ADDENDUM # 2

BID # 7461213

**BID TITLE: MAXIMUM SECURITY HVAC STEAM DISTRIBUTION
UPGRADE**

THIS ADDENDUM ADDRESSES QUESTIONS RAISED AT PRE BID AND SUBMITTED ELECTRONICALLY.

VAD DESUPERHEATER
6/6" CLASS 300
6" [150] HEADER SIZE
OUTLINE DIMENSIONS

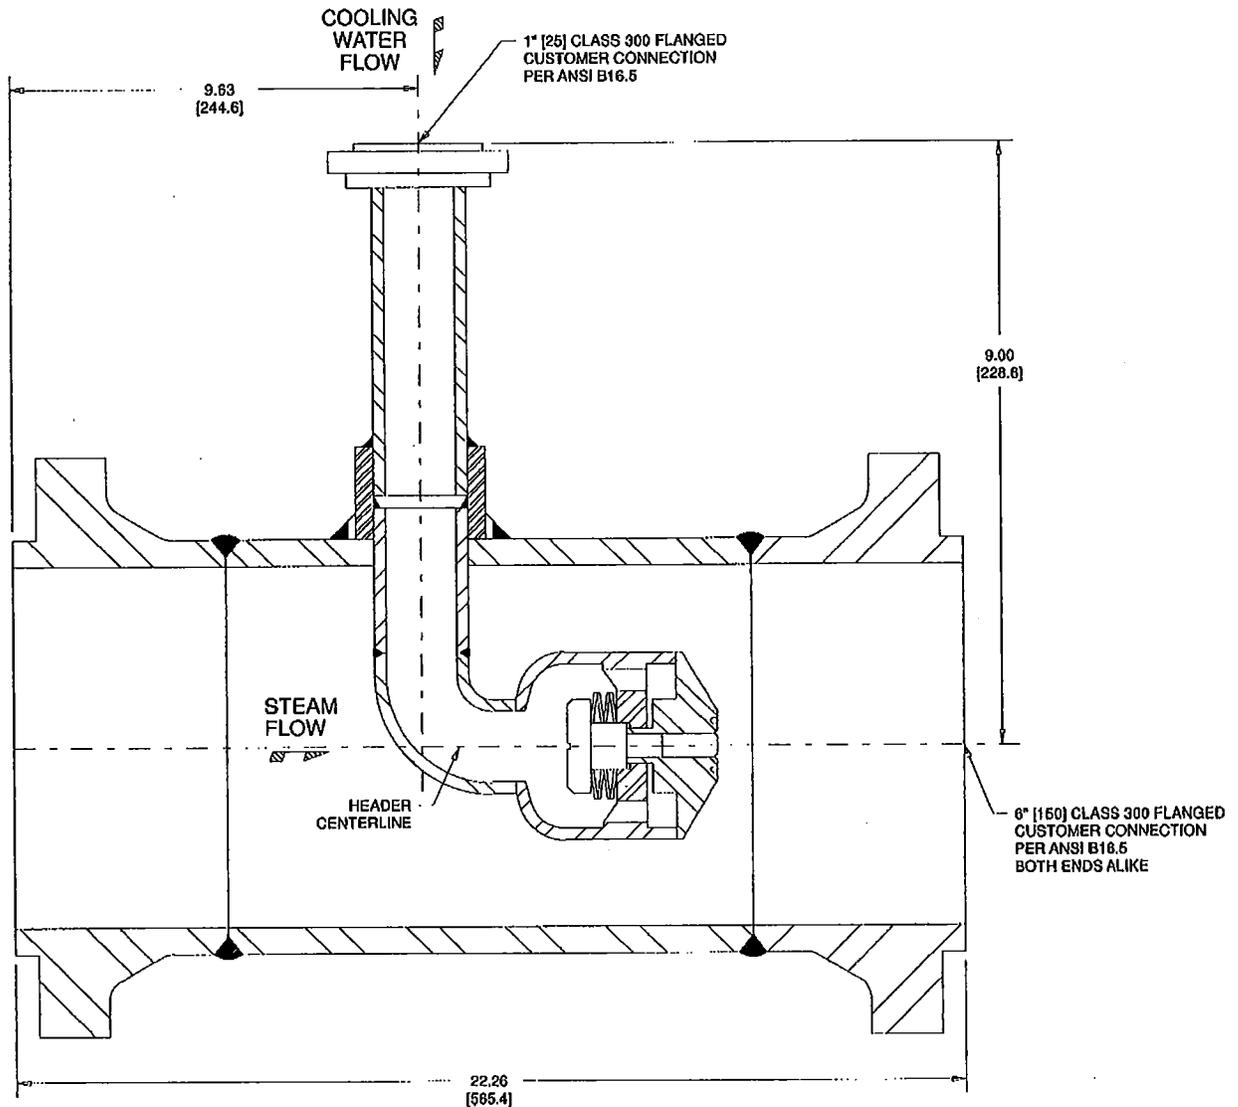
- A. Installation of a Copes Vulcan VAD Desuperheater - meeting the attached data sheet and drawing requirements. Contact for an acceptable Vendor is:

Description: **6/6" VAD**
 Pressure Class: **ANSI 300**
 Body Material: **ASTM A-106 GrB**
 Inlet Connection: **6" Flanged ANSI 300 Serrated RF**
 Outlet Connection: **6" Flanged ANSI 300 Serrated RF**
 Coolant Connection: **1" Flanged ANSI 300 Serrated RF**
 Maximum Steam Pressure Drop: **0.382 psi**
 Required Capacity: **10,000 lb/hr**
 Maximum Available Capacity (1/3 Sonic @ Annulus): **35545 lb/hr**
 Minimum Distance Required to Temp Sensor: **26.3 ft (8.0 m)**
 Min. Length of Straight Upstream Pipe: **2.7 ft (.8 m)**
 Min. Length of Straight Downstream Pipe: **13.2 ft (4.0 m)**

1" [25] CLASS 150
 GS SERIES VALVE
 SOCKET WELD ENDS
 WITH MODEL 700-60 RA ACTUATOR

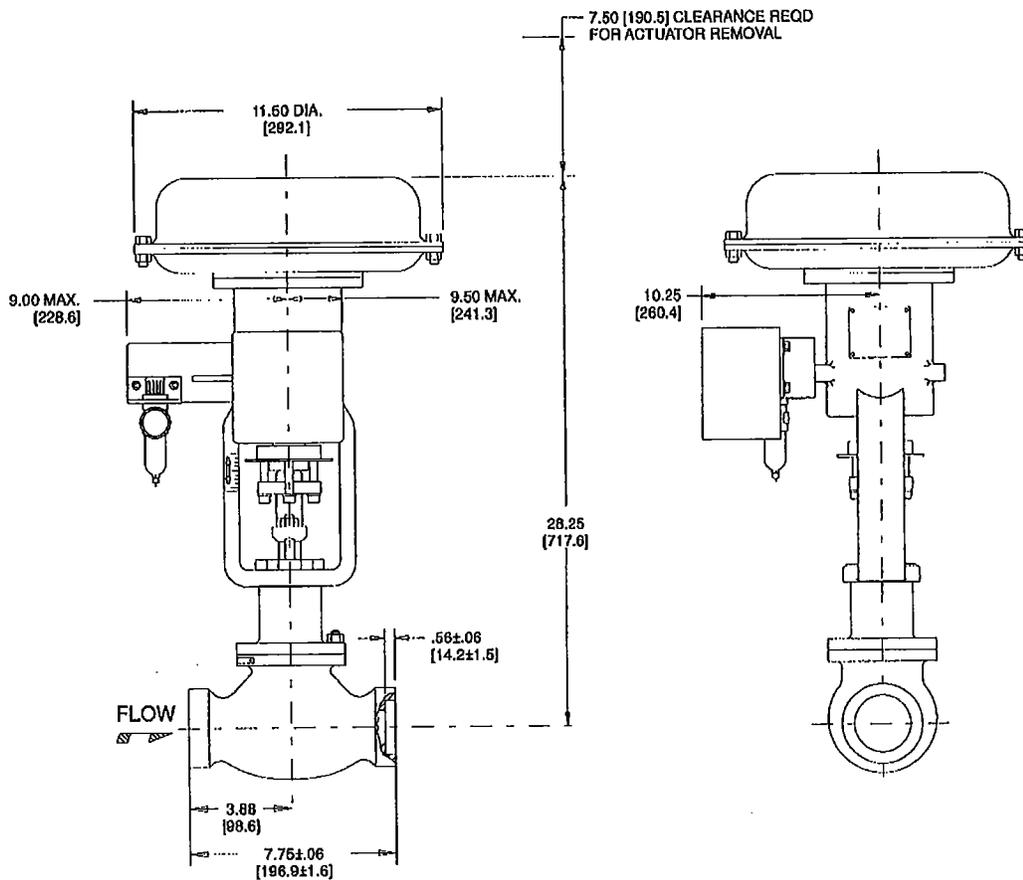
Provide all associated factory controls including inline temperature sensor, valve actuator and standalone controller. All control and power wiring for this valve to be provided and installed by this contractor.
